Newsletter No. CZ 1 – 31.3.2008

New DI-Hammers

Discarding of Hammer HB 210-H25V from DI-Assortiment

New DI-Hammers

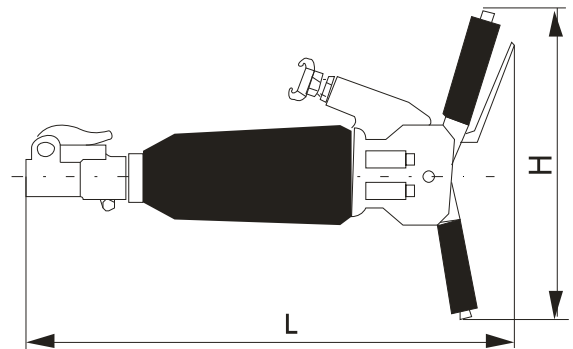
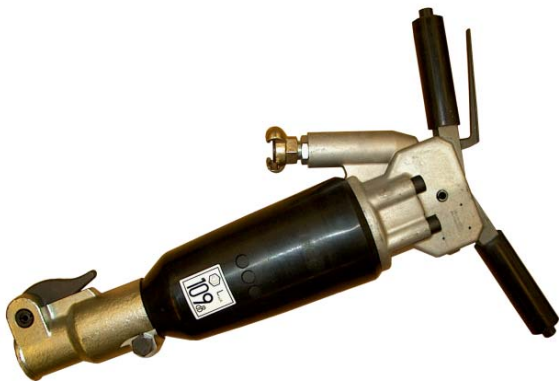
We removed the Hammer HB 210-H25 V from our product line and replaced it with two different models:

HB 200-H25 V (Weight 20kg), HB 250-H25 V (Weight 25kg).

These hammers differ from the old model because of the total weight (was 21kg). Also, an oiler was integrated into the fist-grip. The other technical details remain the same; changes were mainly made to the internal parts. Old parts and new parts are not interchangeable!

The hammer HB 150-H22V was modernized. The original swivel start was replaced by a more ergonomic slider start. The other technical details remain the same; changes were mainly made to the internal parts. Old parts and new parts are not interchangeable!
